Date: 28/04/2020

To: Elyse Neville  
Senior Consents Planner  
Otago Regional Council

## **Oceana Gold Deepdell North Stage III project – Final review**

**Figure 1: Watercourse map.** The western tributary of Highlay Creek that could be impacted by discharges is indicated by red oval, the Gully Stream which will be reclaimed is indicated by the purple oval and the Highlay Tributary that will be culverted is indicate by the orange oval.

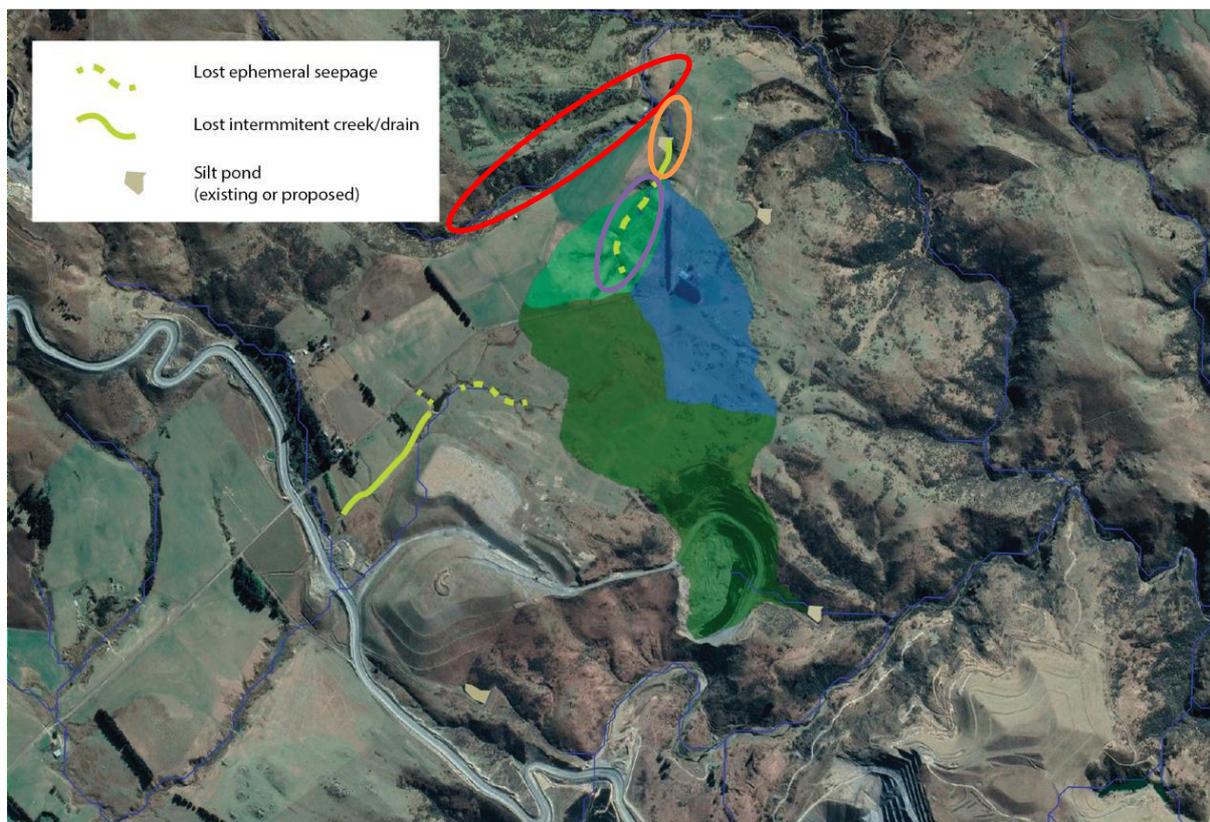
As I understand it, contaminants discharged from the proposed rock stack will enter a Western Tributary (location shown in Figure 1) of Highlay Creek via surface drainage (flowing through sediment ponds) and groundwater contaminated with seepage. However, very little effort has been made to assess the effects that the activity will have on the water quality of the Western Tributary or Highlay Creek itself. Given the presence of koura and flathead galaxiids in both of these streams and the good condition of the macroinvertebrate community (MCI = 108 to 111) protection of aquatic fauna against toxic contaminants is of vital importance.

In my opinion the effects of the discharge of contaminants to Highlay Creek or its Western Tributary (location shown in Figure 1) have not been properly assessed in the Ecological Effects Assessment. In that report, they have only discussed the potential for effects to arise from sulphate and nitrate. However, the effects of toxicants such as arsenic have not been considered. To complete my full assessment, I require the applicant to assess the ecological effects of the discharge standards requested for Highlay Creek in Section 1.2.3. (including nutrients and their effects on periphyton).

The applicant is proposing to reclaim approximately 480 metres of stream in the Highlay Creek catchment (hereafter referred to as the “Gully Stream” (location shown in Figure 1)) that runs down a gully within the proposed project footprint. In the Ecological Effects Assessment, it is estimated that approximately 250 metres of this is ephemeral and the remaining 130 metres is potentially intermittent. The Ecological Effects Assessment also suggests that these reaches do not support fish or typical stream invertebrate habitat and associated communities and are unlikely to carry surface flow during warmer months of the year. Based on this assessment it is concluded that the effects of reclamation will be minor in the report.

In addition to reclaiming 480 metres of the Gully Stream, the applicant is proposing to construct a 51 metre culvert in an intermittent reach further downstream (hereafter referred to as the “Highlay Tributary” (location shown in Figure 1)) as part of a road realignment. The effects of this culvert have not been explicitly assessed in the Ecological Effects Assessment. While not a major issue, some form of assessment is needed, particularly around construction effects (habitat effects are likely the same as those caused by the reclamation of the Gully Stream).

- The likely contaminant concentrations in both Highlay Creek and its Western Tributary (location shown in Figure 1) and proposed water quality standards for these creeks that can be applied in consent conditions. For nutrients, these standards should be set to control plant growth rather than toxicity;

- Some form of assessment of the effects of culverting the “Highlay Tributary” (location shown in Figure 1), particularly around construction effects (habitat effects are likely the same as those caused by the reclamation of the Gully Stream); and

shown in Figure 1) will not have more than minor effects on aquatic life, provided that construction is undertaken in a manner consistent with the methodology described in Point 21 of Appendix F of the S.92 response.

**Figure 3-4 Coronation Silt Pond Sulfate concentrations**

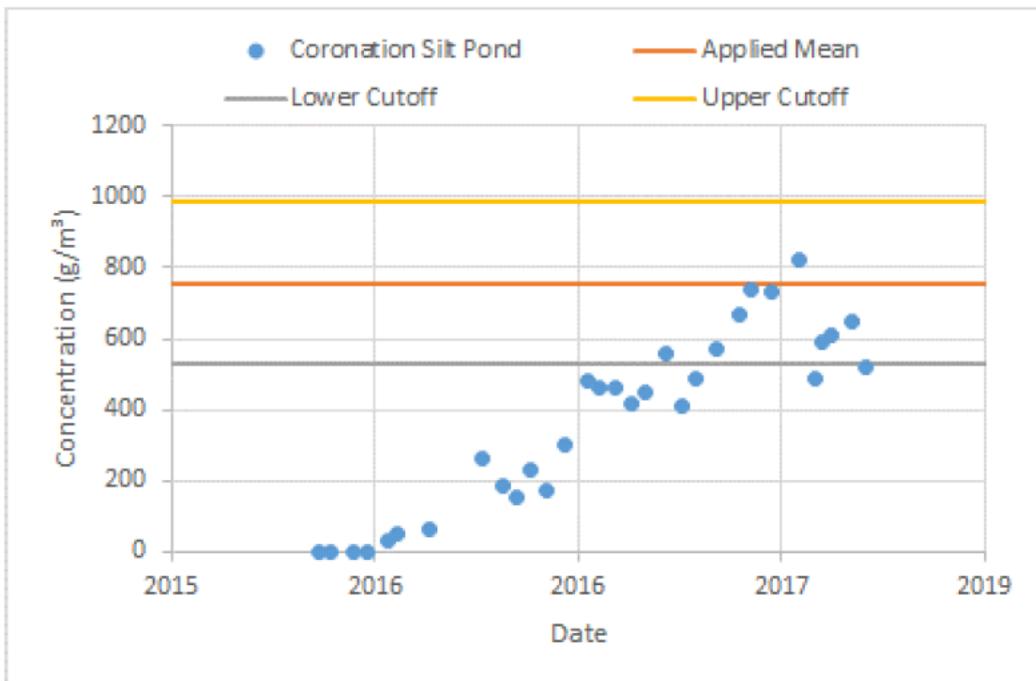
Figure 3-3 to Figure 3-8 of the Appendix E S92 response details the mean, upper and lower concentration bounds of the truncated normal distributions for sulphate. No other modelled water quality parameters have been presented (i.e. nitrate-nitrogen, arsenic, lead) and subsequently, cannot be assessed. Assuming the truncated distribution for these other parameters captures the observed data as per the sulphate examples, this would be

The current upper threshold in GHD’s Figure 3-4 (see image below) for sulphate exceeds the highest recorded observed concentration by ~20%, providing margin for the water quality modelling. Ongoing monitoring is recommended at this site and after 3-4 years should be compared to the modelled truncated normal distribution (i.e. Figure 3-4) to validate the model assumptions. This could be considered in conjunction with flow and water level monitoring recommended in Section 2.1.3 to provide confidence the model suitably captured water quality loads and flow from the disturbed areas of the mine.

Figure 3-13 Comparison of measured and modelled Nitrate concentrations at DC08 for 2015-2018

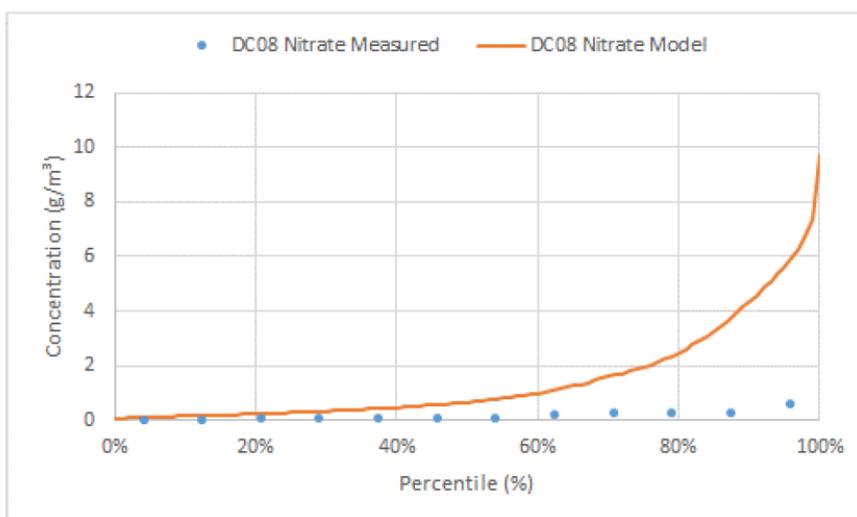
The data presented shows the baseline model is suitably calibrated for scenario assessments of the waste rock stack development and would be considered conservative when simulating sulphate concentrations. Limited monitoring data for nitrate-nitrogen data (see Figure 3-13 presented below from GHD) reduces the confidence in the models baseline calibration for this contaminant, despite the model showing it is conservative in simulating nitrate-nitrogen concentrations. Only 12 sample concentrations are presented over a 3-year period for DC08 and 7 samples at Loop Road. See section 2.2.2 for recommendations.

Further monthly/bi-monthly monitoring of the nitrate-nitrogen concentrations is recommended at DC01 and/or DC08 to validate the background nitrate-nitrogen concentrations and the fixed value of 0.05 g/m<sup>3</sup> applied in modelling, should this consent be granted.
